Access Compliance Report

Public Rights-of-Way

(Pedestrian Signals)

Intersection ID: N/A	Main Street:	Cross Street: N/A	Location: N/A
ADA ID: 7C82D6919FAC	Signal Type: One Push Button-Non APS	Overall Compliance: No	Severity Score: BTN 1: N/A BTN 2: N/A No BTN: N/A
Codes/Mitigation Info/Possible Solution		Field Measurements/Component Compliance

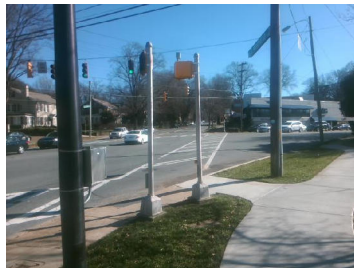
PROW/ADA: , TMUTCD 4e.08, R404.2, R404.3, R406.2

Possible Solutions: Replace Signal Push Button With APS Button on New Post. Remove & Relocate Sign.
